TO: Mercedes-Benz Dealer Principals, General Managers, Sales Managers, Service Managers, Parts Managers	FROM: Gregory Gunther, Department Manager, Vehicle Compliance and Analysis, Engineering Services
RE: Recall Campaign Launch Notification Replace Battery Cover MY18 205 213 (C-Class, E-Class)	DATE: November 20, 2018

Campaign No. 2018110002, November 2018

SUBJECT: **Models C-Class (205 platform) and E-Class vehicles (213 platform)**
Model Year 2018
Replace cover for positive pole on starter battery

Figure 1

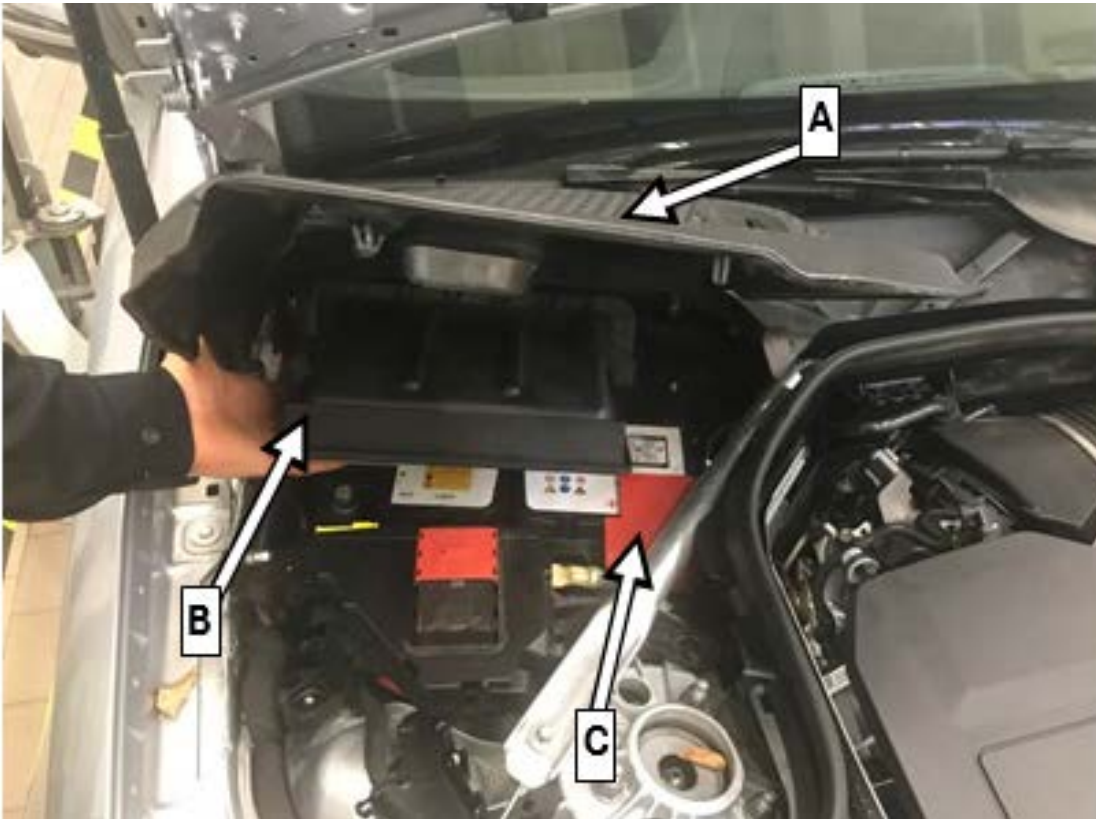
Daimler AG ("DAG"), the manufacturer of Mercedes-Benz vehicles, has determined that on certain Model Year ("MY") 2018 C-Class (205 platform) and E-Class vehicles (213 platform), an incorrect cover for the starter battery may have been installed which provides insufficient cover for a live electrical wire. Therefore, in the event of a crash which results in substantial deformation of the strut brace above the battery, the strut brace could contact an uncovered live electric wire which could lead to a short circuit. A short circuit could lead to an increased risk of fire. In this case, the on-board electrical system might not be able to support post-crash functions (e.g. emergency door unlocking or activation of hazard warning lamps may not be available). However, unlocking and opening of the doors from the inside are not affected. An authorized Mercedes-Benz dealer will replace the battery cover on the affected vehicles.

1. Lift cover (A, Figure 1).
2. Lift interior air filter (B, Figure 1).
3. Replace cover for positive pole (C, Figure 1) on starter battery.

Qty.	Part Name	Part Number	Estimated Replacement Rate
1	Cover for positive pole (insulating cap)	A 000 546 85 02	100%
